Project	IEEE 802.16 Broadband Wireless Access Working Group <http://ieee802.org/16>	
Title	OFDMA PHY Configuration and ASN.1 code	
Date Submitted	2006-03-06	
Source(s)	Joey Chou Intel Corporation 5000 W. Chandler Blvd. Chandler, AZ 85226	[mailto: joey.chou@intel.com]

Abstract	This contribution proposed the text and ASN.1 code for OFDMA PHY.
Purpose	Adoption
Notice	This document has been prepared to assist IEEE 802.16. It is offered as a basis for discussion and is not binding on the contributing individual(s) or organization(s). The material in this document is subject to change in form and content after further study. The contributor(s) reserve(s) the right to add, amend or withdraw material contained herein.
Release	The contributor grants a free, irrevocable license to the IEEE to incorporate material contained in this contribution, and any modifications thereof, in the creation of an IEEE Standards publication; to copyright in the IEEE's name any IEEE Standards publication even though it may include portions of this contribution; and at the IEEE's sole discretion to permit others to reproduce in whole or in part the resulting IEEE Standards publication. The contributor also ack

7 13.1.1.5 wmanIfBsPhy

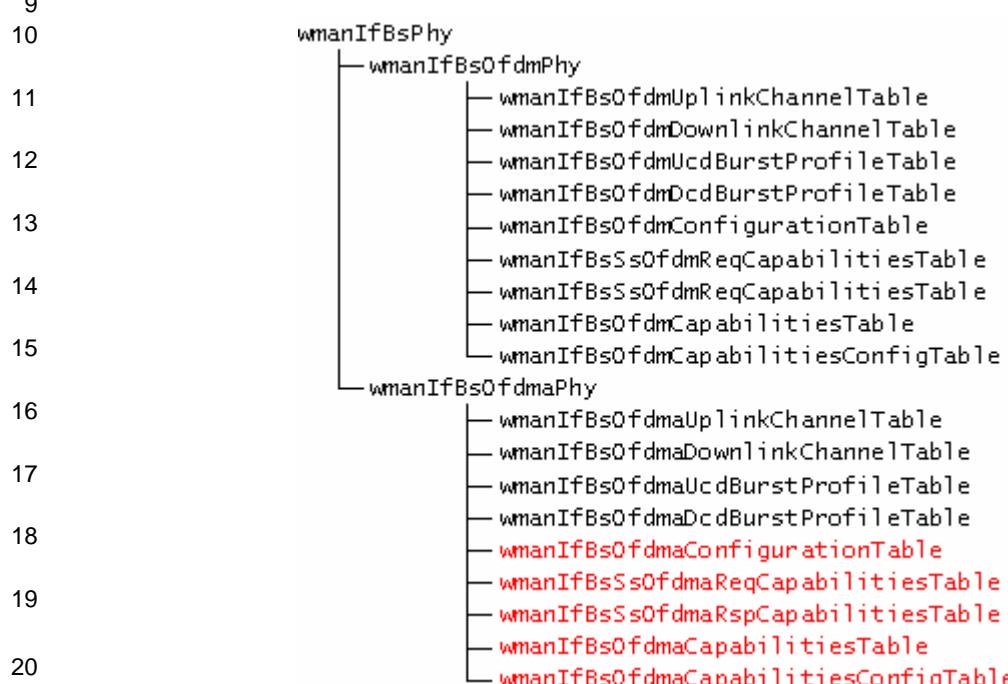
8 *[Replace the Figure 7 with the following:]*
